Addendum No. 2

**CITY OF ABERDEEN
ABERDEEN, MARYLAND
DEPARTMENT OF PUBLIC WORKS**

AAWWTP Digester Gas Flare Replacement

Engineering Project No. 12563982

Title	DRIP TRAP CHAMBER PLAN AND SECTION
Sheet No.	M-02101
Sheet	23 of 28

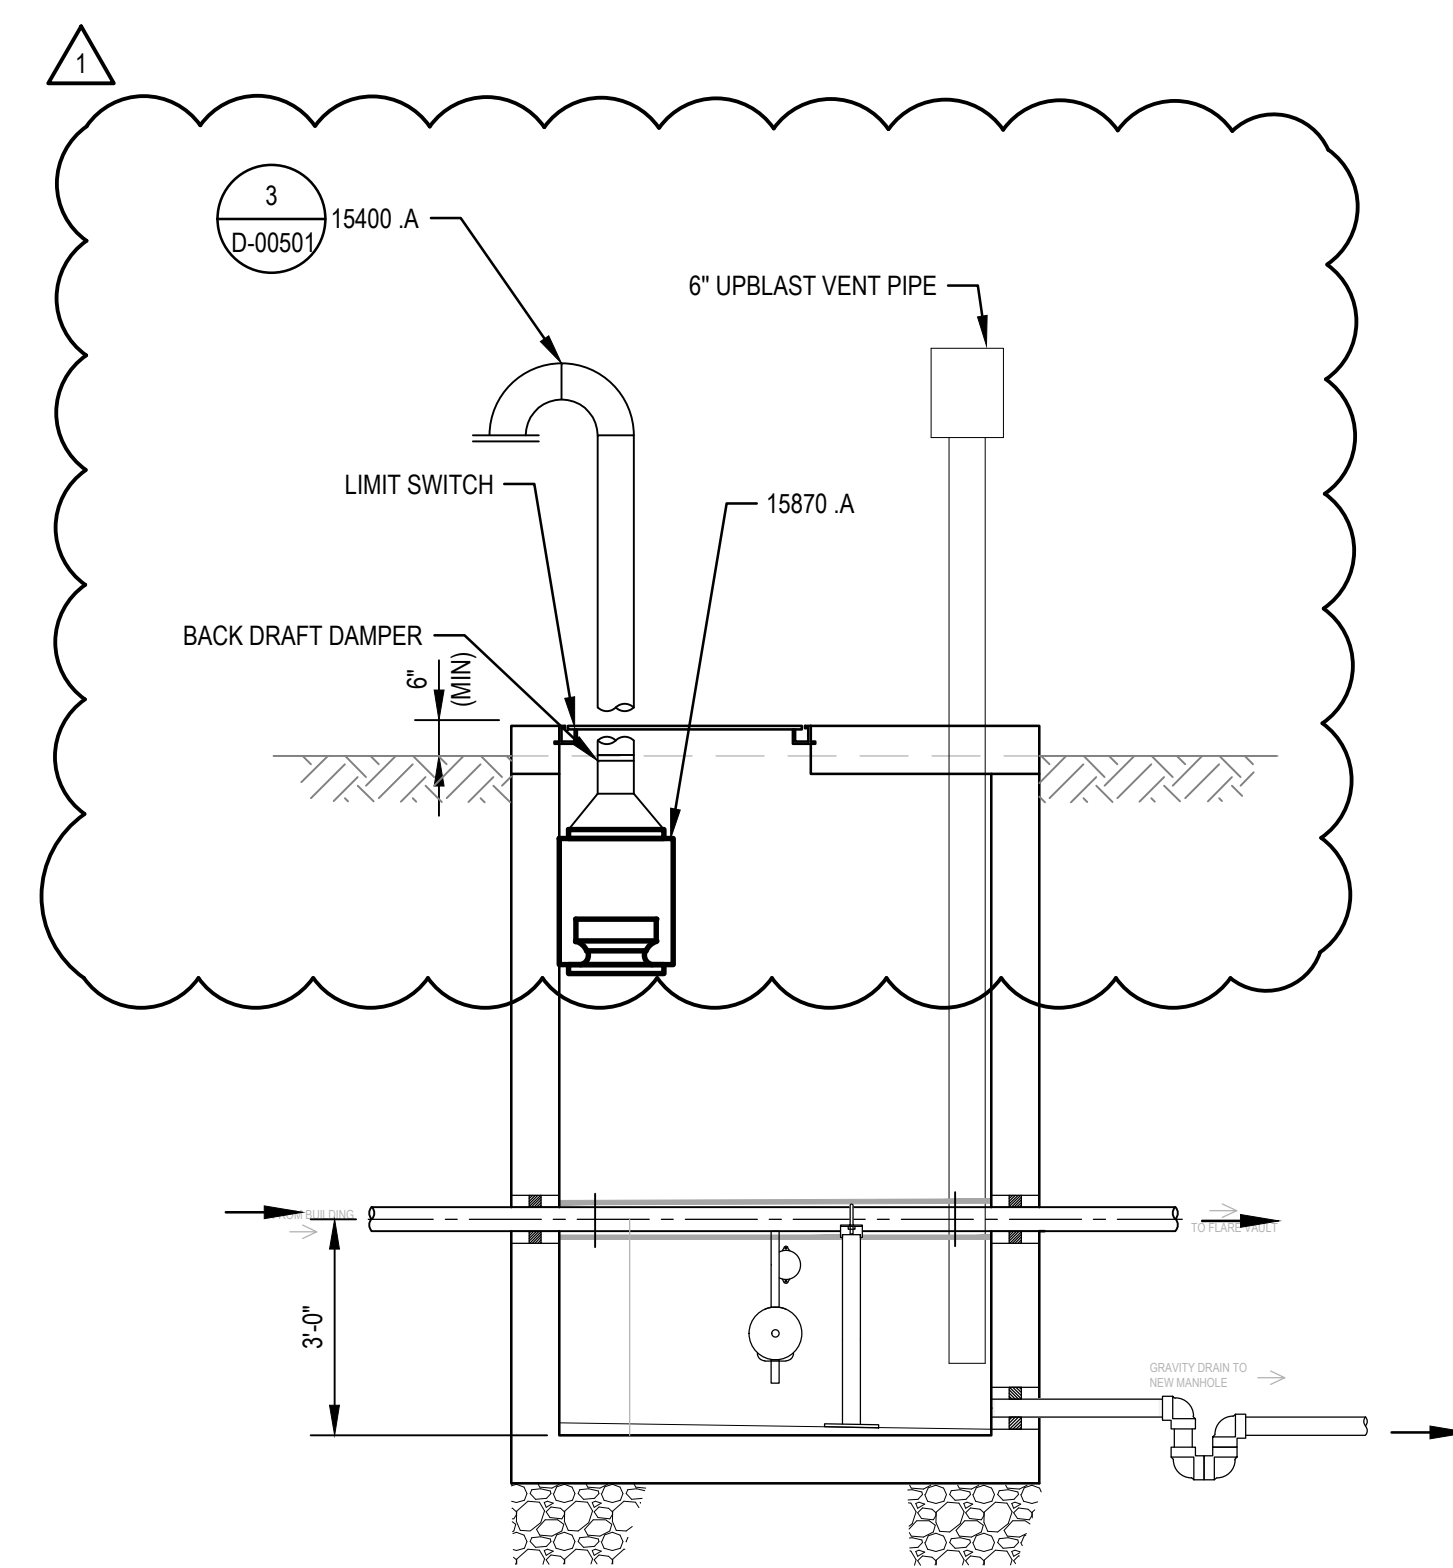
What is the material specification for the upblast pipe shown on M-02101?

Provide a stainless steel upblast pipe of the same material as the intake pipe on the vaults.
